PLAN FOR PROPOSED WORK SHOP ON
PLOT NO 26 SHEET NO E-11

The work proposed Shed (workshop)

With reference to your application dated 3rd December 1930, with a plan for the proposed building additions and alterations on plot No. 26, Survey Sheet No. 288, Lawrence quarter I have the honour to inform you that until the following requirements are complied with plans cannot be passed:—

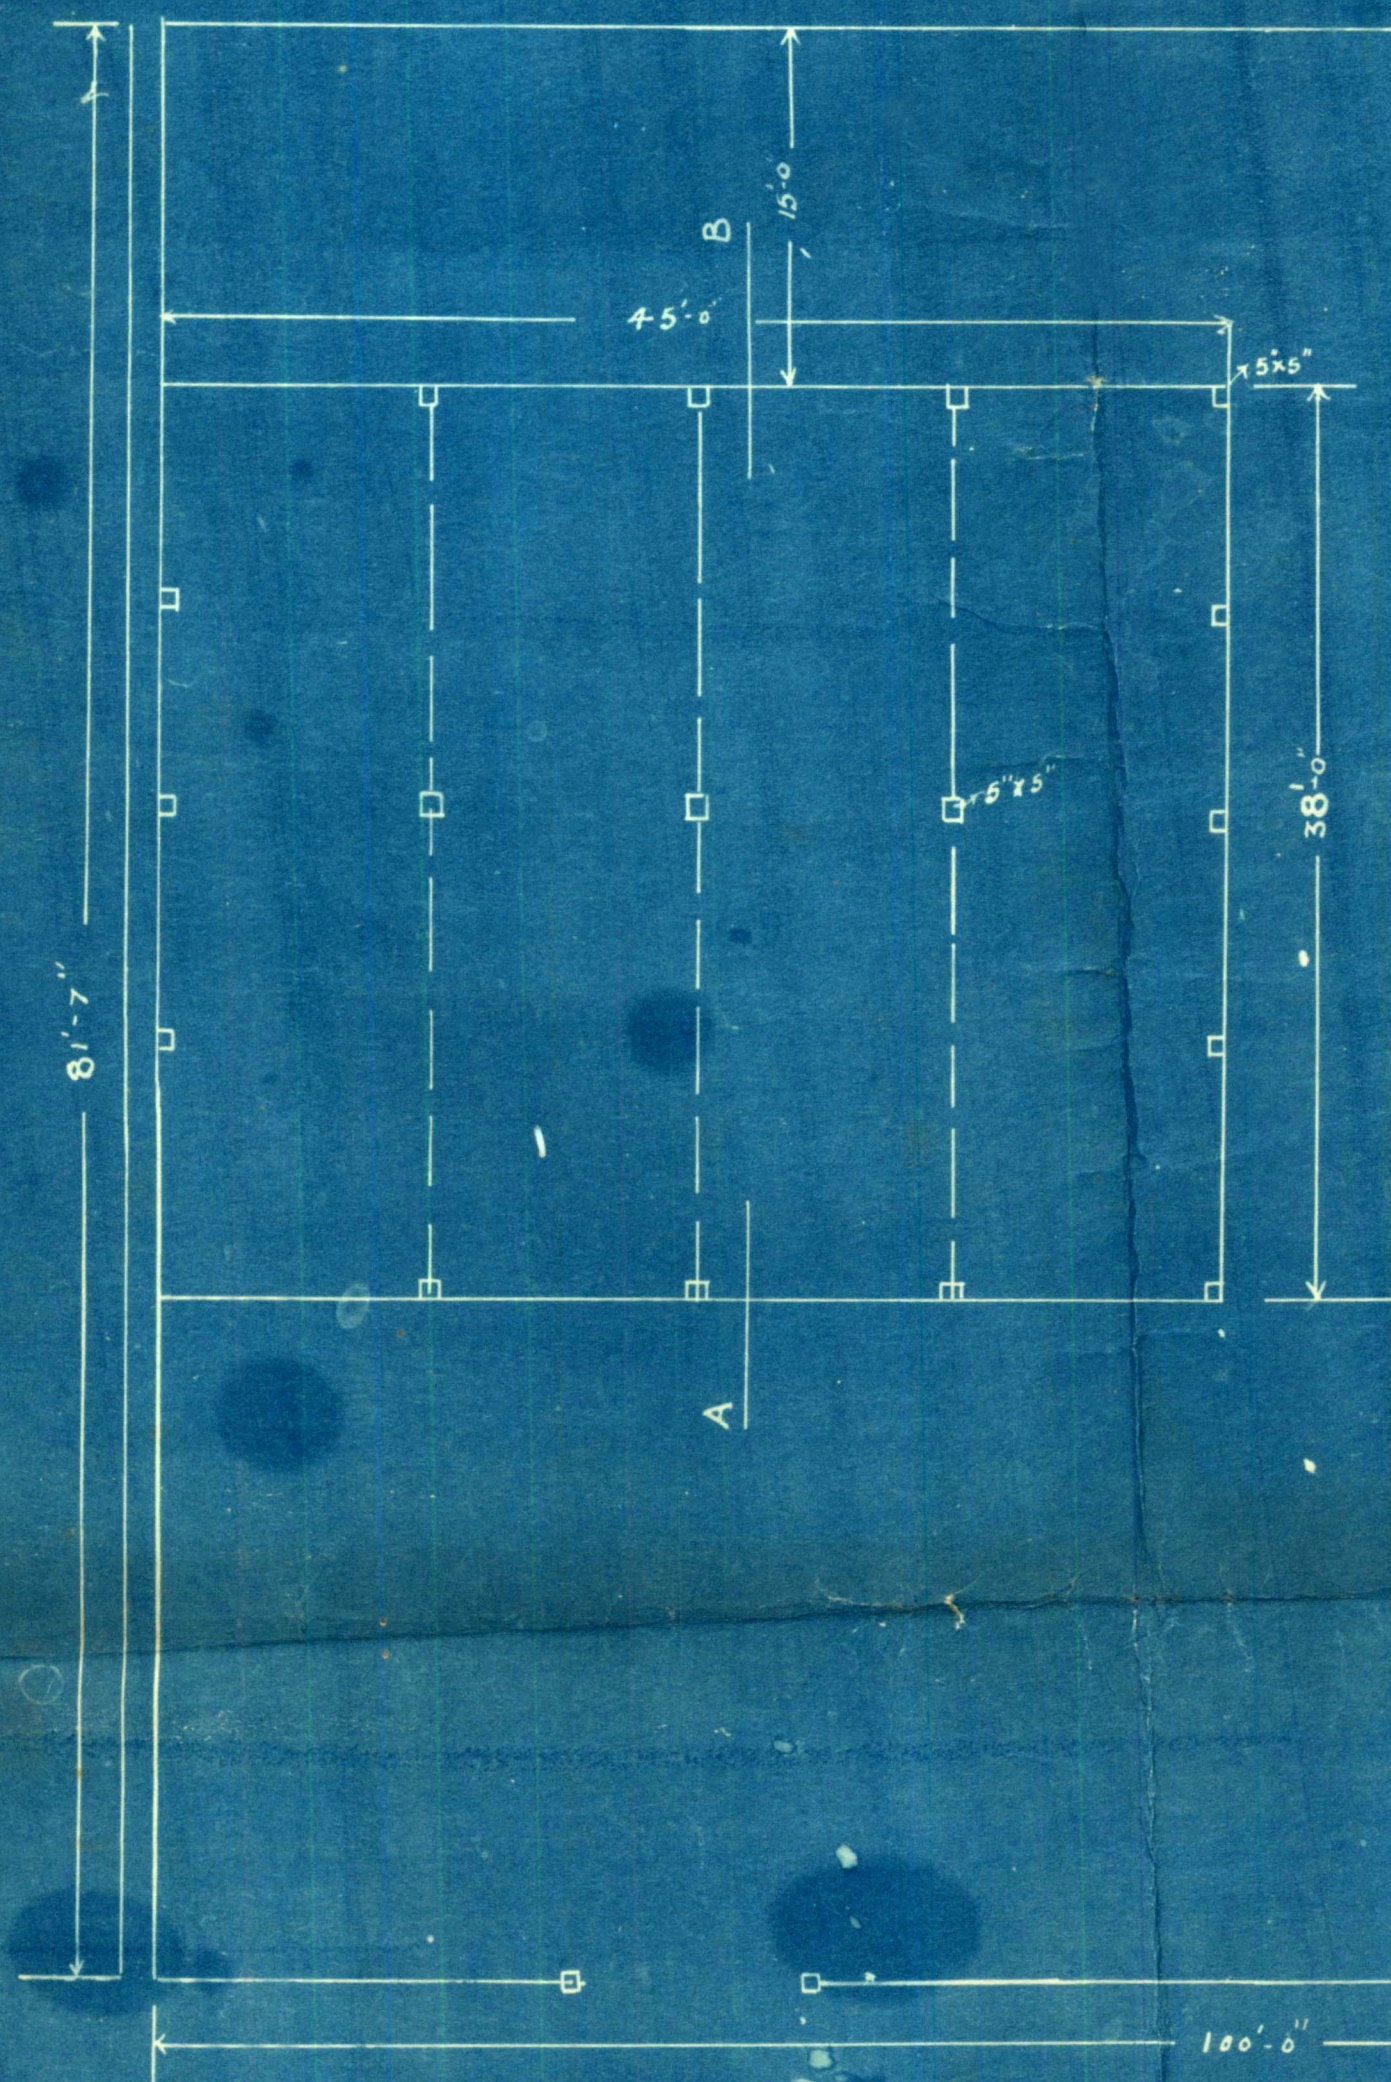
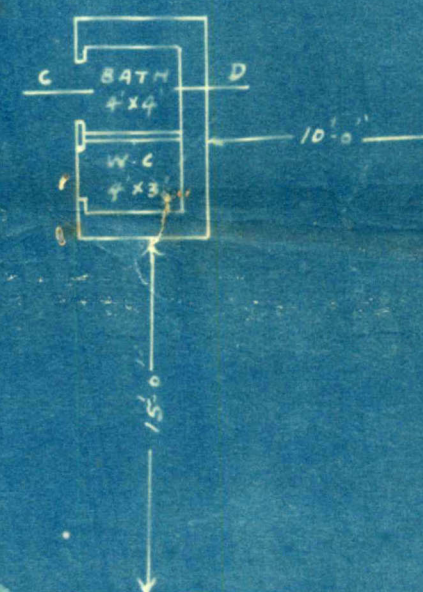
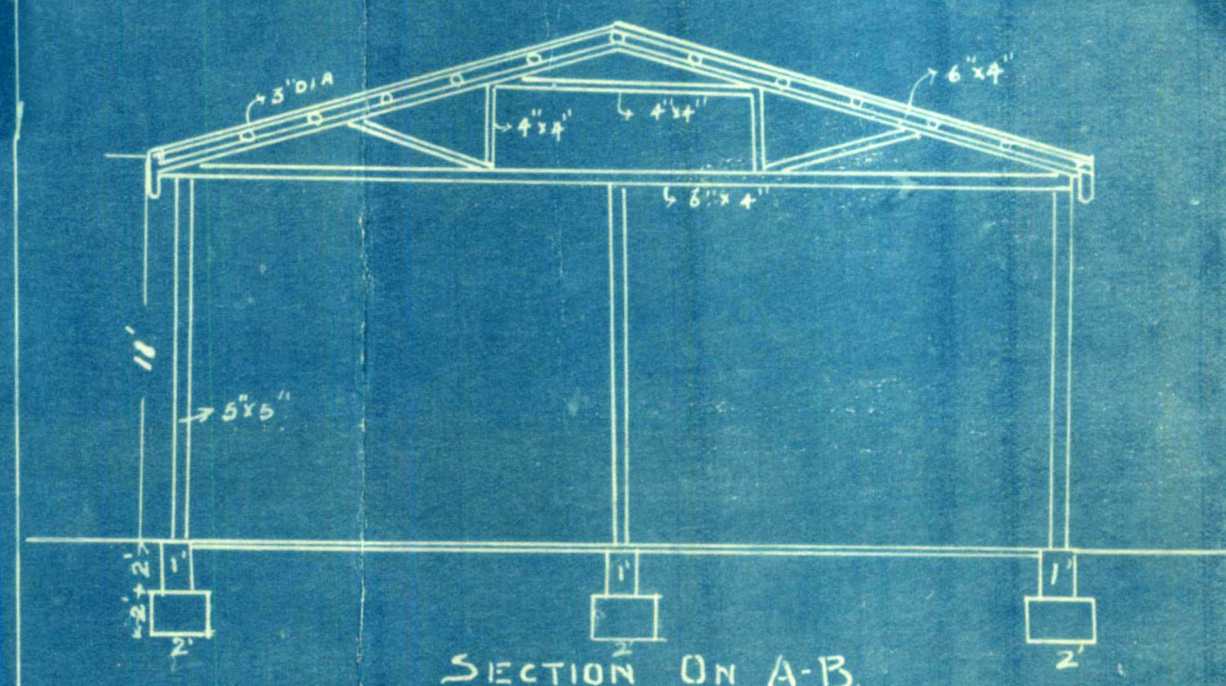
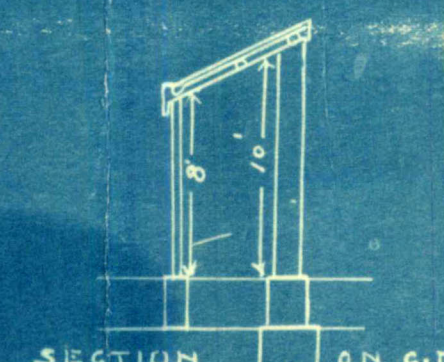
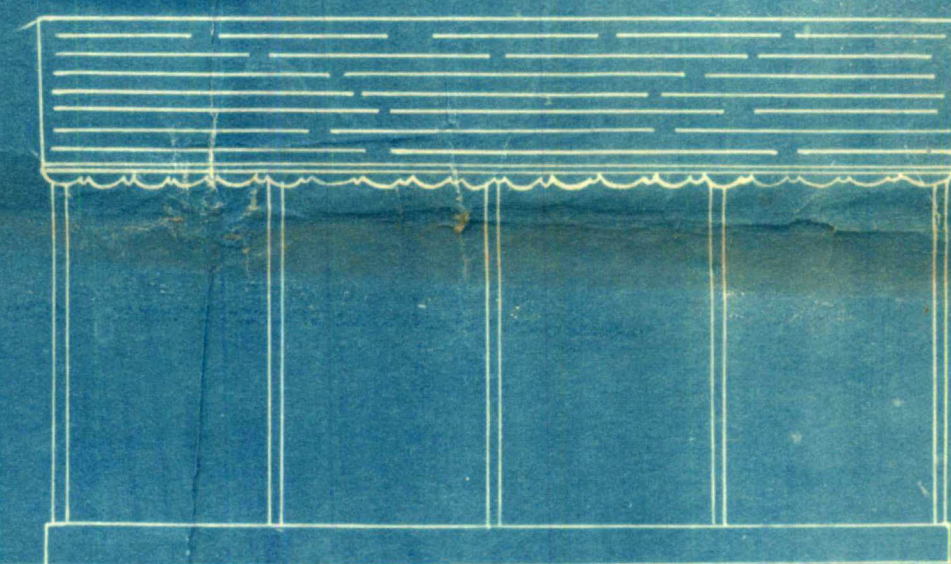
- (1) Does the plot come under Alignment? yes
- (2) Is the Alignment Correctly Shown? Alignment line is not correctly shown on the adjoining plot
- (3) Are the Site Measurements correct? yes, except one (east side measurement is not correct)
- (4) Is there any encroachment? No
- (5) Is the plot affected by T. P. Scheme? yes

- (1) Alignment is not correctly shown.
- (2) Measurements are not correct.
- (3) Post plates must be shown.
- (4) 3" purlins would not do for 9'.
- (5) Nature of roof must be given.
- (6) Nature of side walls be given.
- (7) Workshop must be shifted 15' from proposed road.
- (8) No - Compensation Agreement to be given.
- (9) Owner's signature etc is required.
